Limitations of the Hawkins Rumker Project REF

The Rylstone Region Coal Free Community (RRCFC) has reviewed the Hawkins Rumker Project REF report and has found there are fundamental flaws in the assessment.

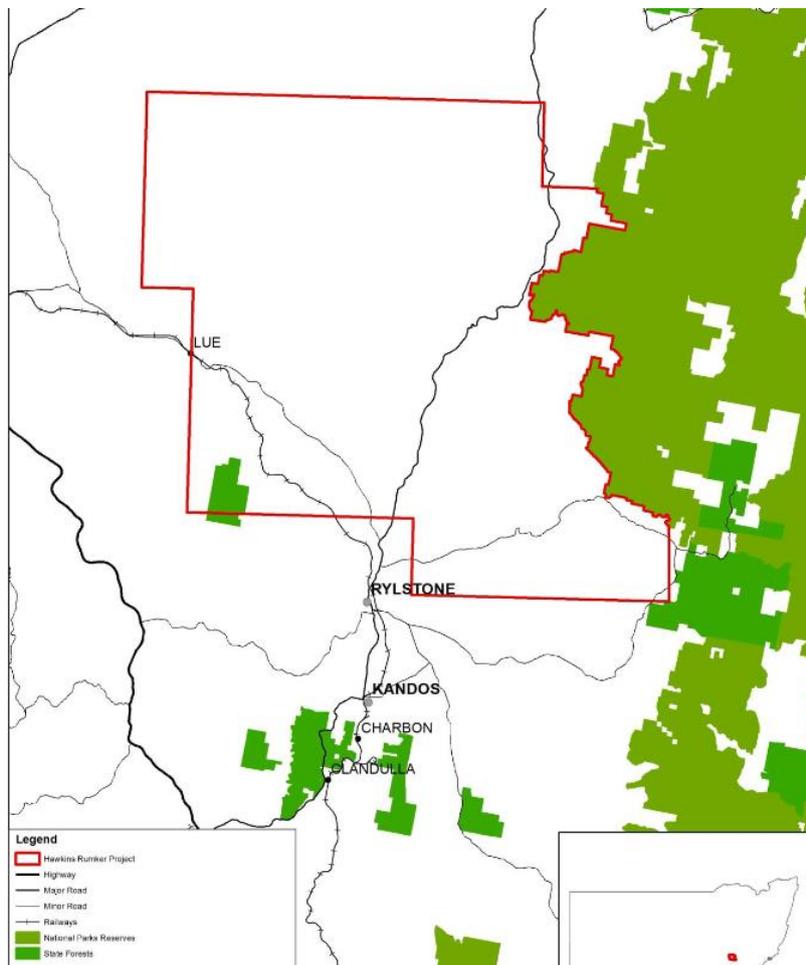
There are a number of issues with these statements.

A search of the NSW National Parks and Wildlife Service Atlas of NSW Wildlife search in 2015 would have in fact revealed a number of threatened flora. Below is a discussion of what would have been present, as well as what could have been found with further investigation, as the RRCFC did in a matter of a couple of hours.

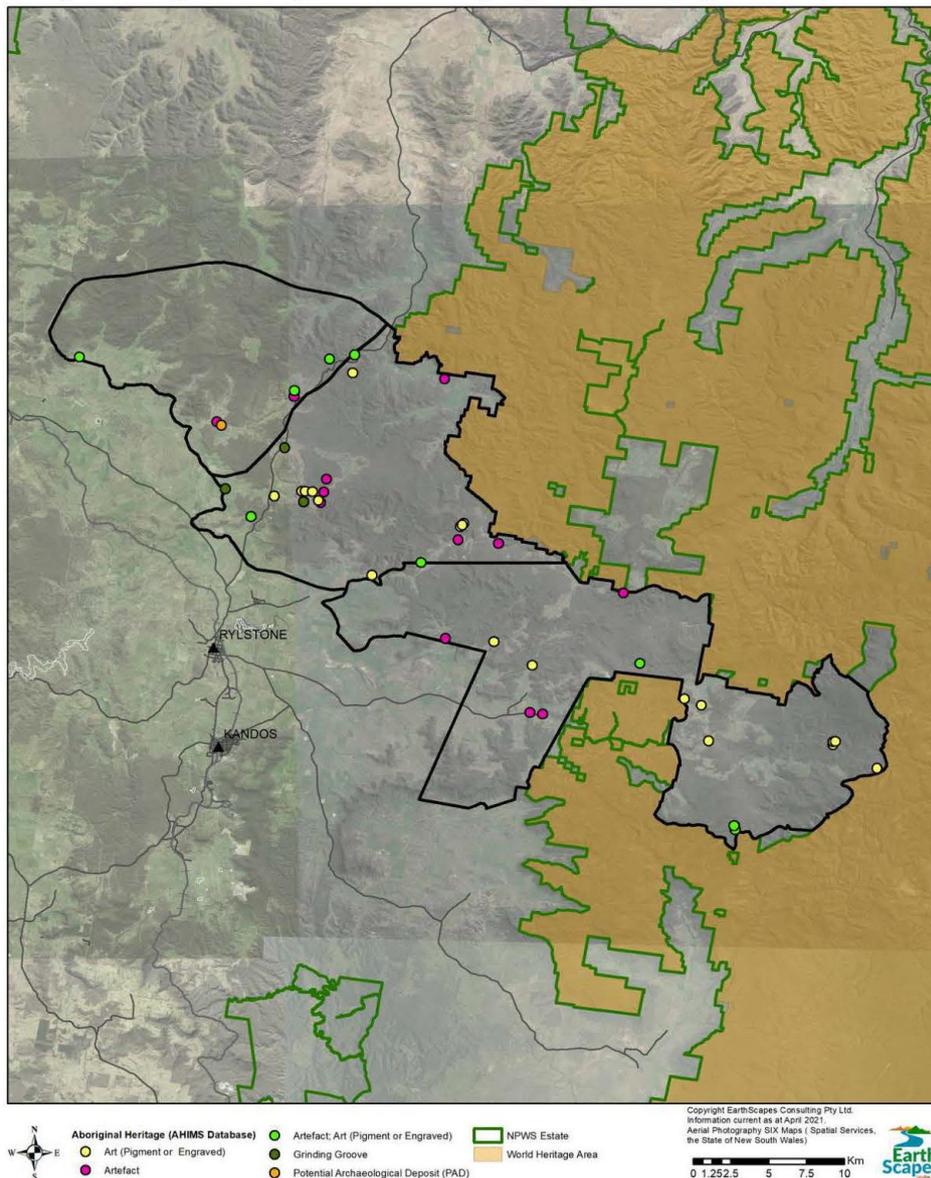
The REF gives the commitment '*no threatened ecological species, population or communities will be adversely impacted*'. This statement cannot be made based on the level of desktop investigation and that only desktop investigation was undertaken as part of the REF. As the information has not been assessed to the fullest possible extent, or even to a reasonable extent, it is not possible to conclude this.

To properly inform the REF, further investigation should have been undertaken by an ecologist within the proposed drilling locations and along any areas being disturbed through earthworks or slashing to determine what threatened species were present.

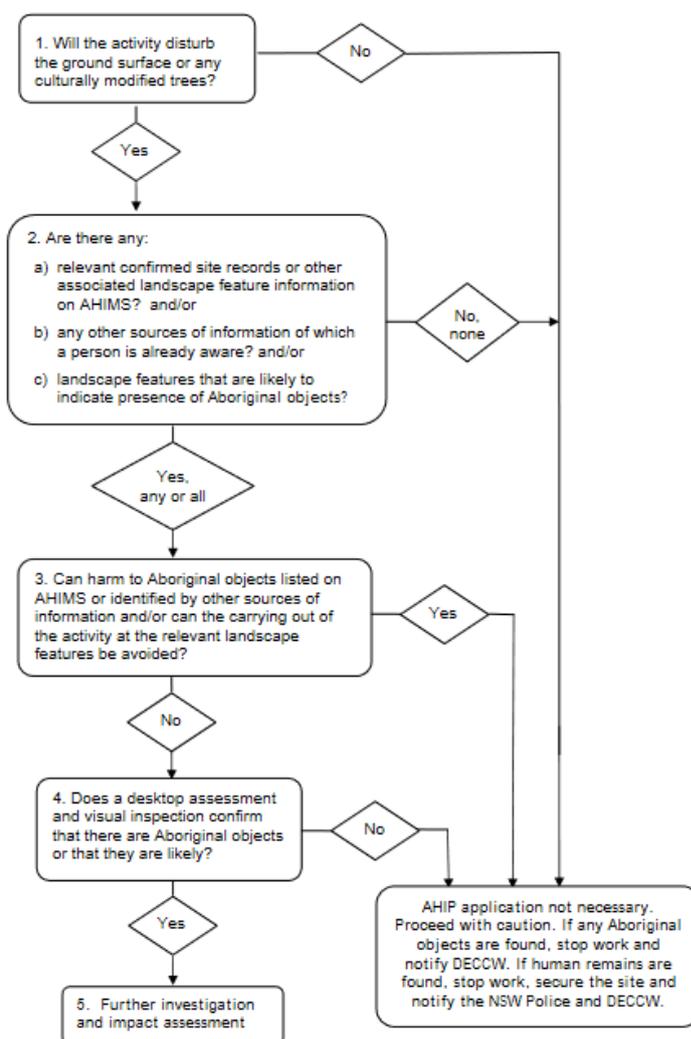
The statement that the sites are on disturbed land is not consistent with the description given in the REF, which says ‘exploration sites are mostly well covered in a mixture of native and introduced grasses. The grasses support grazing, predominantly by cattle. The areas surrounding the exploration sites vary from grasses to lightly timbered areas. These timbered areas mainly consist of native trees and shrubs with a grassy understorey.’ Therefore, the Clause 80B Defence of carrying out certain low impact activities cannot be applied.

When land is not disturbed and there is no Clause 80B Defence, the flow chart from the Due Diligence Code of Practice for the Protection of Aboriginal Objects in New South Wales (2010) (below) is to be followed. This should have resulted in further investigation; however, from the information outlined in the REF this has not been undertaken.
